ADDENDUM NO. 2 - TO ALL BIDDERS

Reference – INVITATION FOR BID (IFB) #2002

LACKEY GRAVITY SEWER REHABILITATION – PHASE 1

Lackey Gravity Sewer Rehabilitation – Phase 1

**FINAL PAVEMENT
 RECONSTRUCTION DETAIL**
 NOT TO SCALE

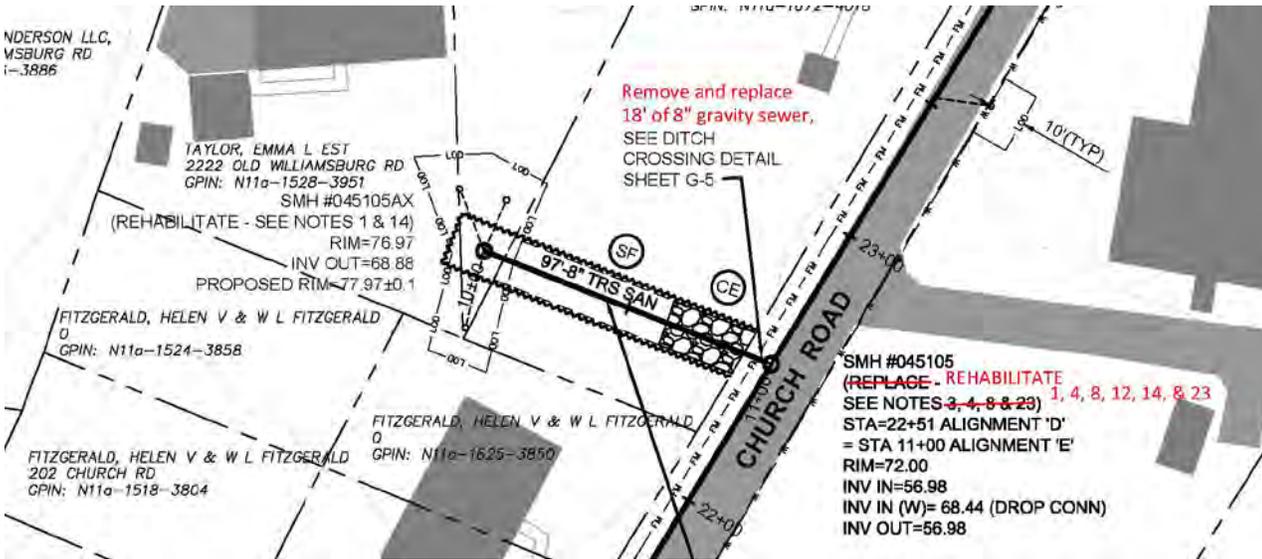
6. What is the difference between Bid Item Nos. 11 and 12? What are the thicknesses, and what are the units, as the units are contradictory between measurement and payment vs. bid form for Bid Item No. 11.
Bid Item No. 11 is a temporary pavement repair, whereas Bid Item No. 12 is a permanent pavement repair. See detail below for Reconstructed Asphalt Pavement (Bid Item No. 12).

NOTE:
 1. WHERE THE SUPPLEMENTAL VDOT TYPE 21-B STONE WILL BE PLACED ON SUBGRADE MATERIAL, A GEOTEXTILE STABILIZATION FABRIC CONFORMING TO THE REQUIREMENTS OF VDOT SPECIAL PROVISION FOR SECTION 245 - GEOSYNTHETICS, SHALL BE PLACED ON THE SUBGRADE BELOW THE SUPPLEMENTAL TYPE 21-B STONE.
